THE TOWN OF KILL DEVIL HILLS
NORTH CAROLINA

Memorandum

Subject: **SITE PLAN REVIEW**— 100 East Fifth Street — Proposed Cluster Home Development — Including 11 “4-Bedroom” and 2 “3-Bedroom” Residential Units and Community Pool with Pool Building.

Subject: **SITE PLAN TECHNICAL REVIEW 2** —100 East Fifth Street in the Commercial Zone —
Proposed Cluster Home Development —Including 11 “3-Bedroom” and 2 “4-Bedroom”
Residential Units and Community Pool

POOL & BATH HOUSE
PLANNING BOARD REVIEW
PRELIMINARY DRAWINGS NOT FOR CONSTRUCTION

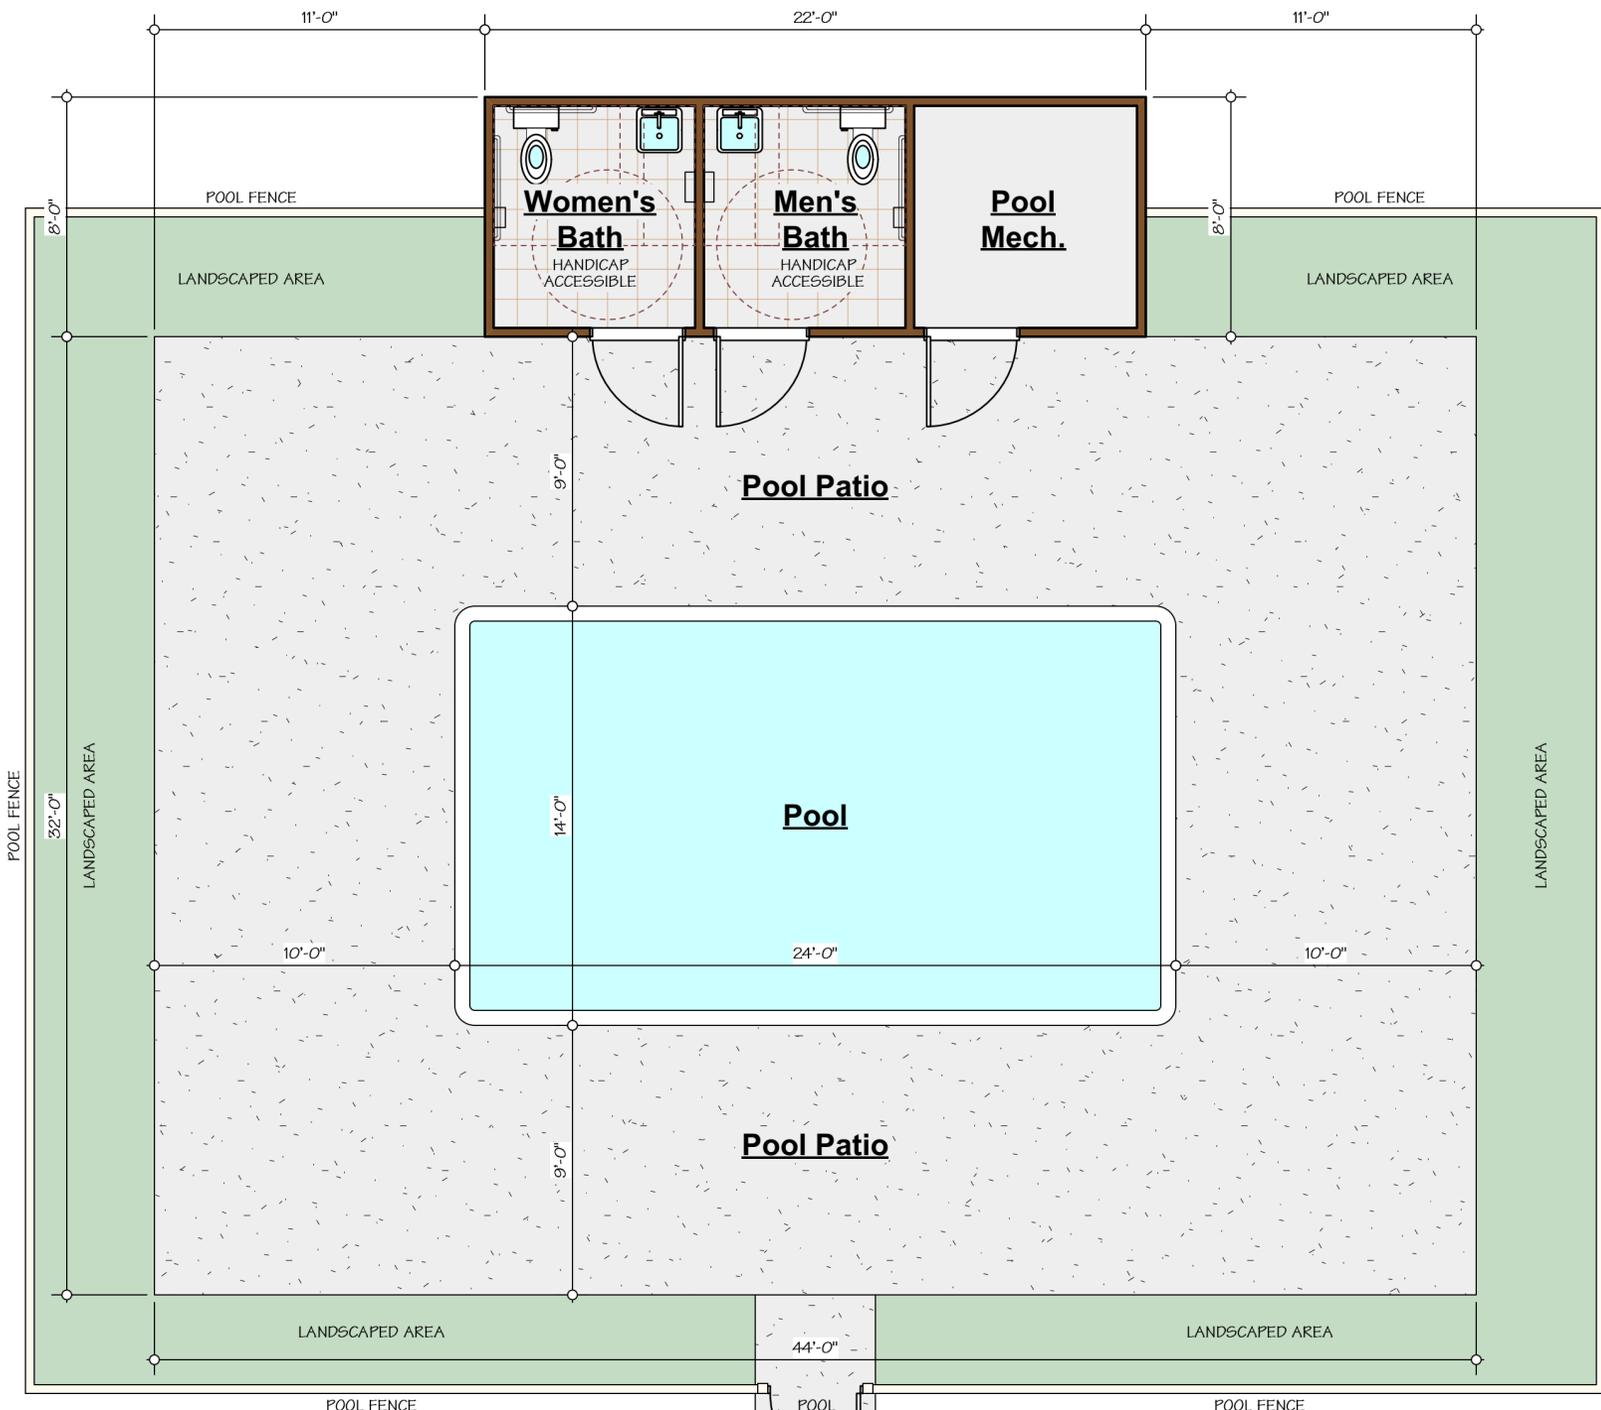
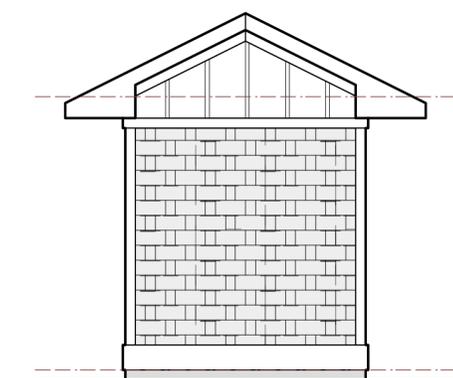
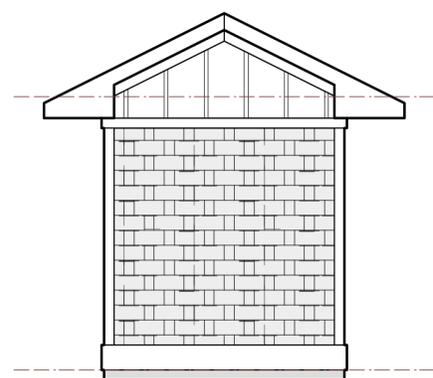
1. Proposed Architecturals for Pool Building does not meet the requirements of 153.186 Commercial Building Exterior. Roof Height is required to be 6 feet from top plate to the ridge. Roof slope, roof overhang, and materials used for building construction are not identified.
2. Remove bold property lines from Lot 525, Avalon Beach Annex 1 on Site Plan.
3. Construction entrance detail corrected to 50’ depth.

DATE:	SCALE:
01-31-22	1"=20'
DESIGNED: MWR	DRAWN: MWR
SHEET: 8	OF 9
CAD FILE: c:\p\street cottage court-4th-base.dwg	PROJECT NO: 051121

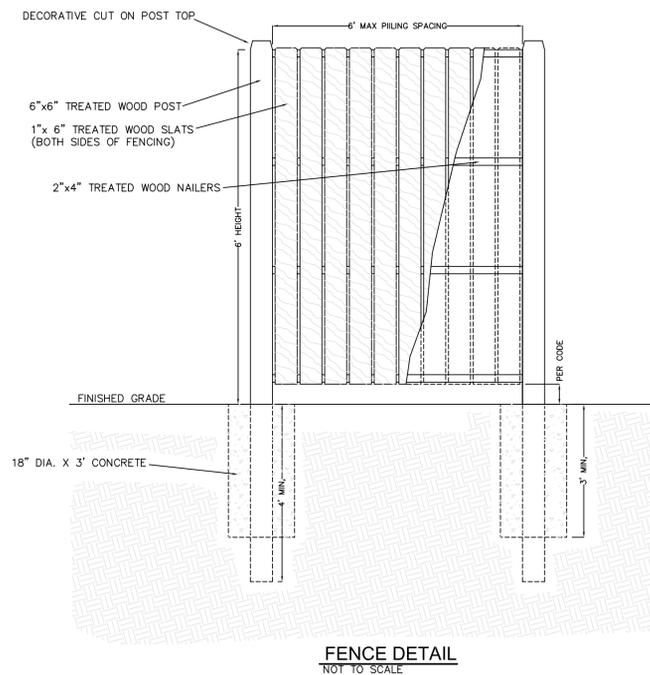
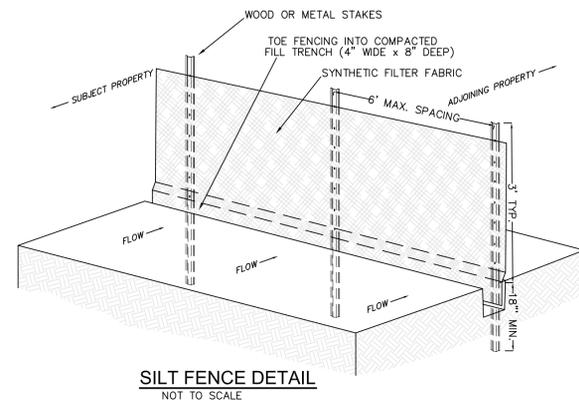
1. Revise construction entrance detail, 50' deep and “5th Street”. **Detail corrected**
2. List number of plantings provided. **Additional planting may be added but the minimum will be met. See notes on Sheet 8 (lower left)**
3. Revise Landscape Buffer Table: Property Corner D to A “Dense Vegetative Screen along North Property Line with Fence Buffer between incompatible uses.” **Done**
1. Provide Proposed Architectural and Floor Plan for Bath House and Pool Mechanical Building. **Included with this submittal**

- b. Sheet 8; on Gravel Construction Entrance detail, change "Virginia Dare Trail" to "Public Street". **Done**
 - c. Sheet 8, Stormwater Calculations: We recommend revising the calculations of storage volume and associated cross section to reflect Interstitial Storage depth of 2.5', from the top elevation of 7.0 down to elevation 4.5. The resulting volume reduction still leaves the project well over the required "managed" volume of a 4.3" rain event. And the 0.20 porosity is conservative. Further, with the groundwater managed down by the "sock drain" system, as discussed below, effective interstitial storage will not be confined within downward vertical projections of the top-of-bank lines. **Calculations adjusted**
